Draft decision

Jemena electricity distribution determination

1 July 2026 – 30 June 2031

Attachment 3 – Operating expenditure

Figure 3.1 Historical and forecast opex (\$million, 2025–26)

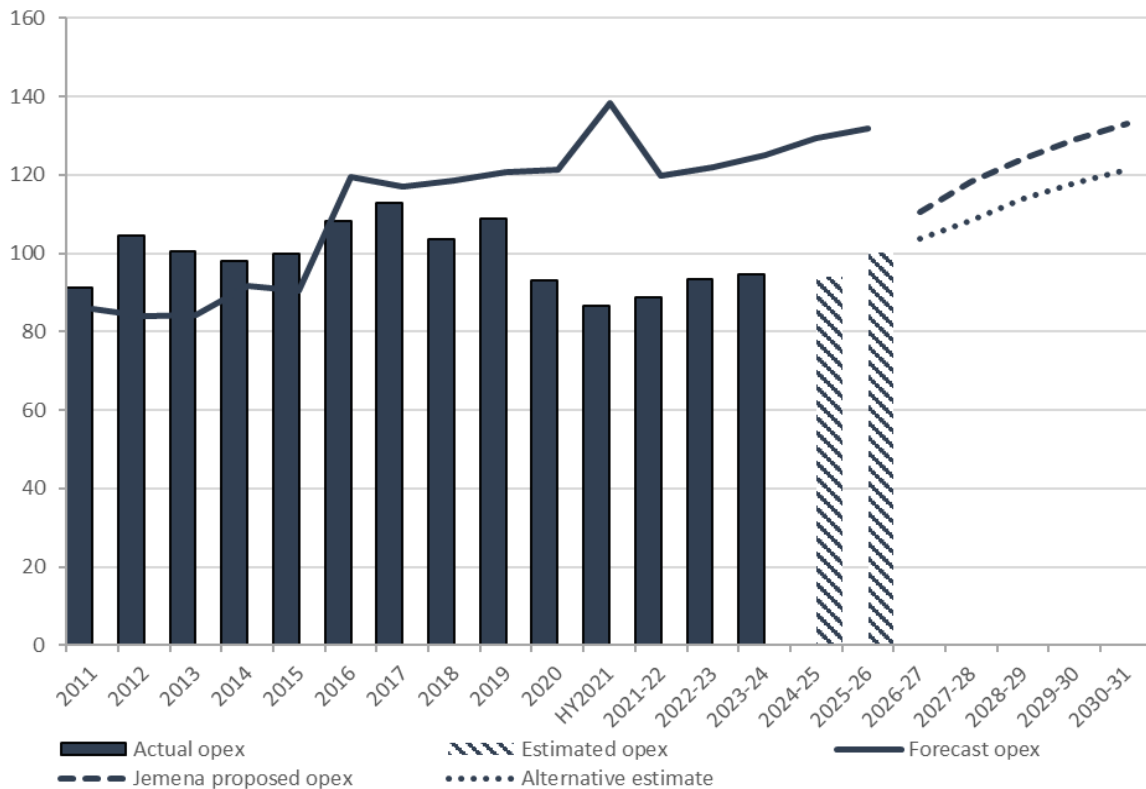
In Figure 3.1, we compare our alternative estimate of opex to Jemena's proposal for the next regulatory control period. We also show the forecasts we approved for the last 2 regulatory control periods, and Jemena's actual and estimated opex over these periods.

Figure 3.2 Jemena’s opex forecast (\$million, 2025–26)

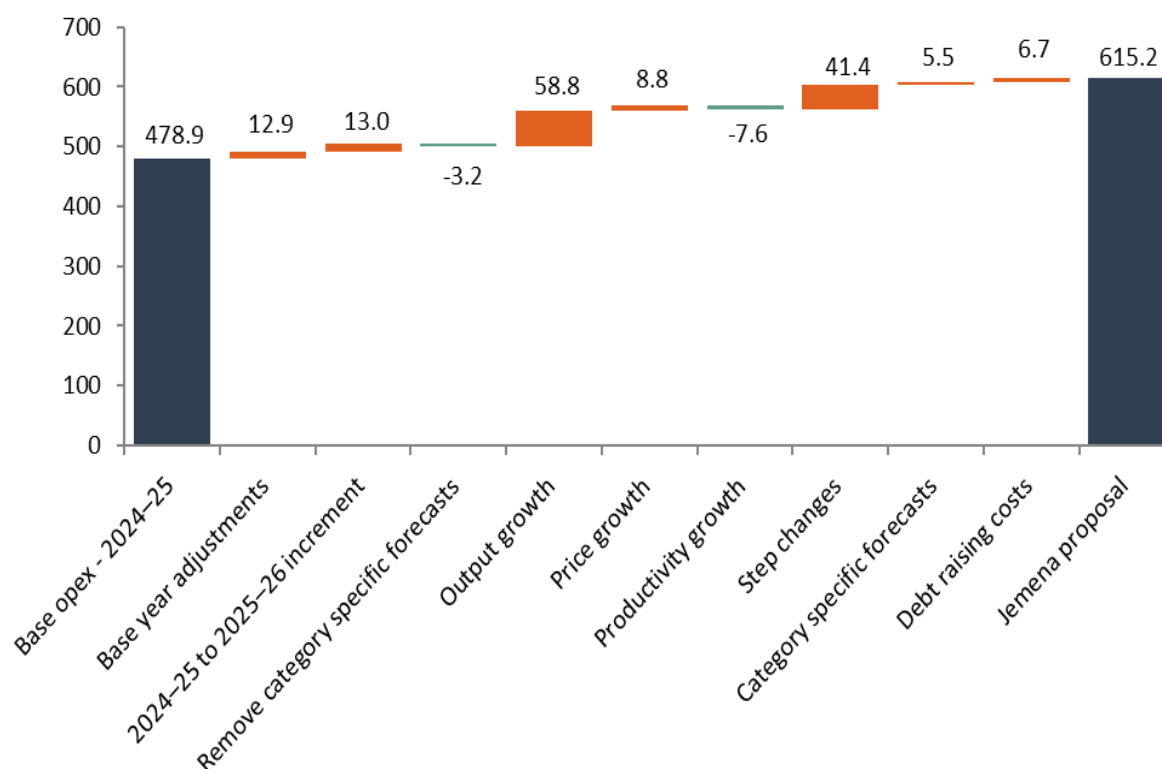
Jemena’s method of applying our base step trend approach is set out in Table 3.1. In Figure 3.2 below we show the different components that make up Jemena’s opex forecast for the 2026–31 period.

Figure 3.3 Econometric opex efficiency scores and opex MPFP, 2006–23

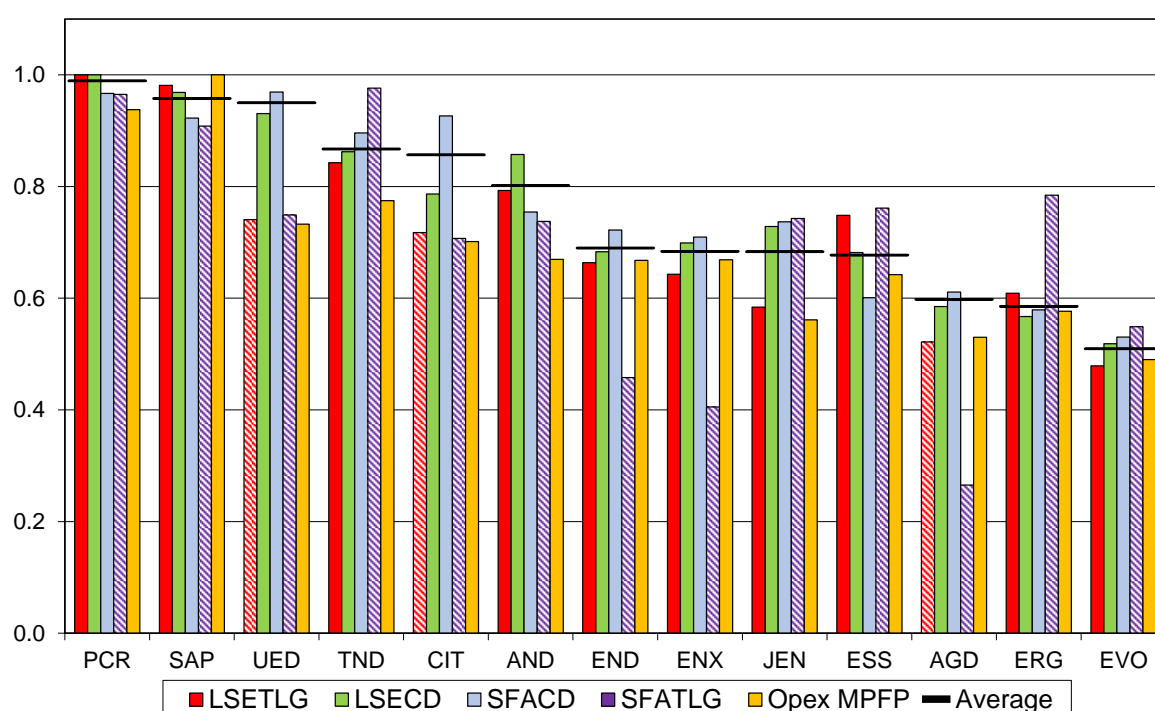
Figure 3.3 shows that over the long period, Jemena is ranked 9th out of 13 DNSPs (with an average efficiency score of 0.68), while Figure 3.4 shows that it ranked 11th over the short period (with an average efficiency score of 0.65).

Figure 3.5 Individual DNSP opex MPFP indexes, 2006–23

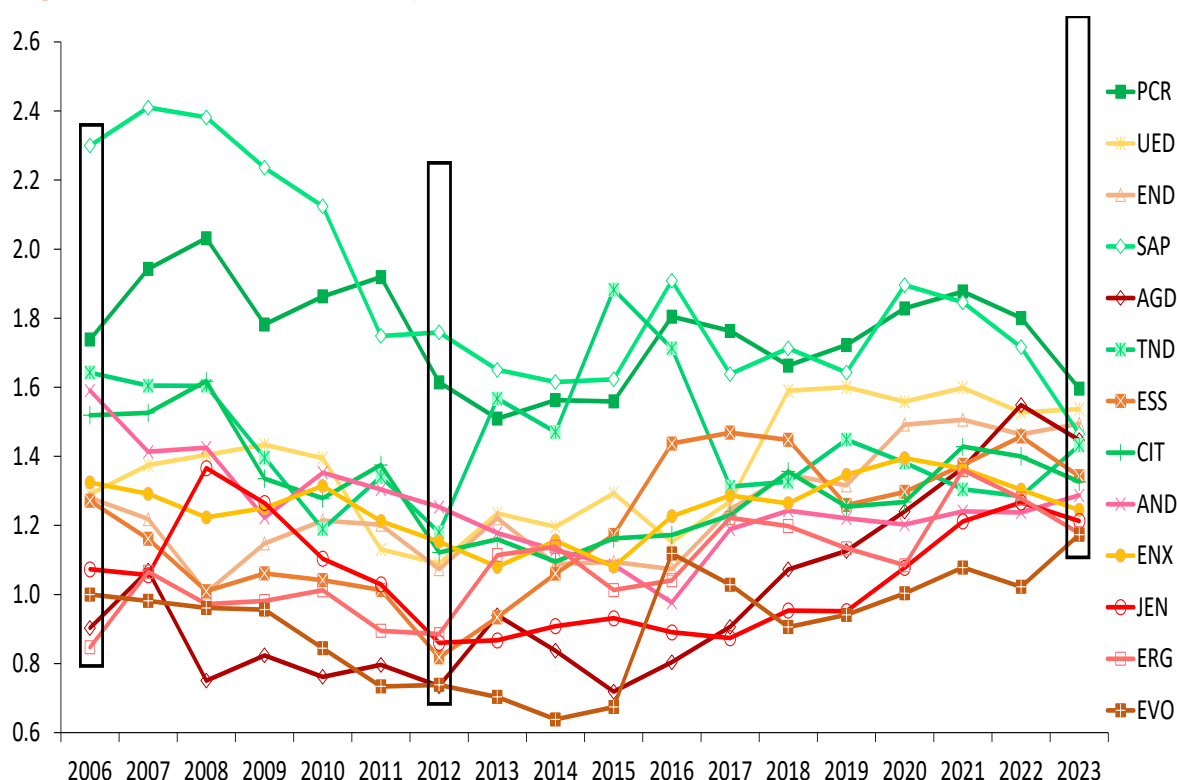
The results from our opex MPFP analysis can be seen in Figure 3.5 (where a higher index score means more efficient). Jemena has typically ranked among the lowest performing distribution businesses in terms of opex MPFP. Jemena's performance remained fairly constant between 2012 and 2019, leading to its ranking falling slightly as some other distribution businesses improved their performance. In 2017, Jemena became the lowest performing distribution business as measured by opex MPFP. Since then, its performance has gradually improved, returning to a ranking of 11th in 2022 and 2023.

Figure 3.8 Estimates of efficient network services opex using data over the 2006–23 period

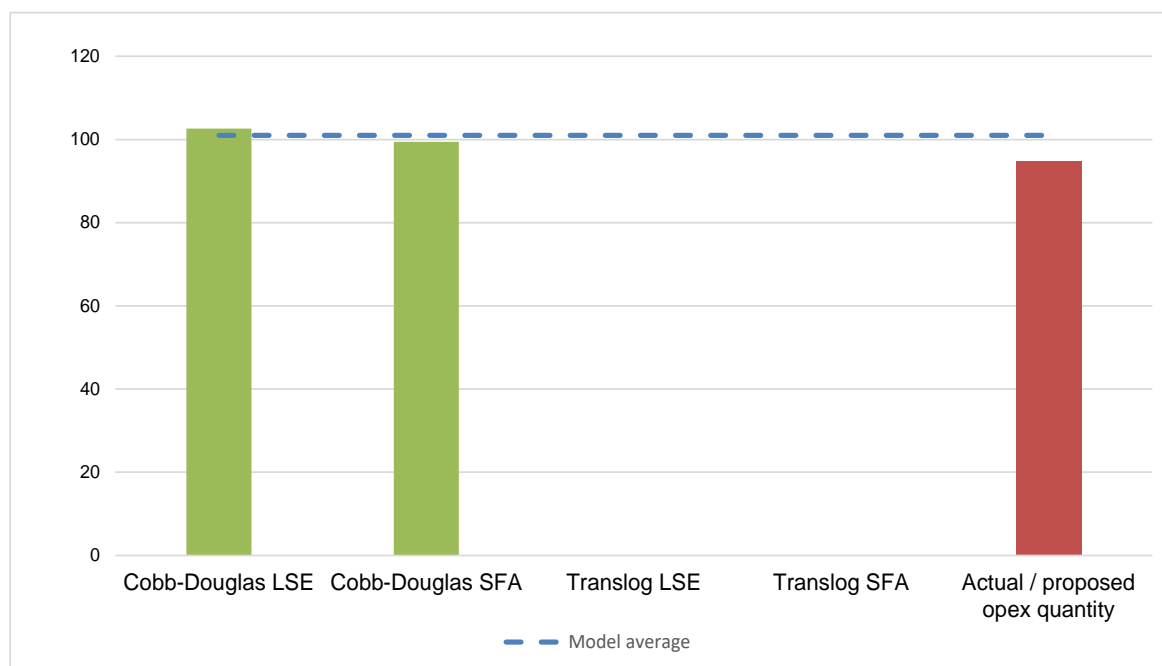
Given the evidence outlined above about the possible inefficiency of Jemena’s opex over the 2006–23 period, and the more recent 2012–23 period, we have undertaken further analysis. Consistent with past decisions, this involves the application of our economic benchmarking roll-forward-model, which includes adjusting for OEFs to test the efficiency of the 2024–25 base year opex more directly. We use the results from our econometric opex cost function benchmarking and our benchmarking roll-forward models to derive an estimate of efficient base year opex, and compare this efficiency opex estimate to Jemena’s 2024–25 base year opex. We then determine whether there is an efficiency ‘gap’, and if so, the magnitude of this ‘gap’. We have outlined our approach in further detail in past decisions.²⁵ The results of using our benchmarking roll-forward model (as discussed above) to derive estimated efficient base year opex plus capitalised corporate overheads (blue dashed line), and compare it to base year actual opex plus capitalised corporate overheads (in green), are set out in Figure 3.8 for the long period and Figure 3.9 for the short period.

These figures show that Jemena’s estimated 2024–25 base year opex is below our estimated efficient base year opex across the long and short periods.
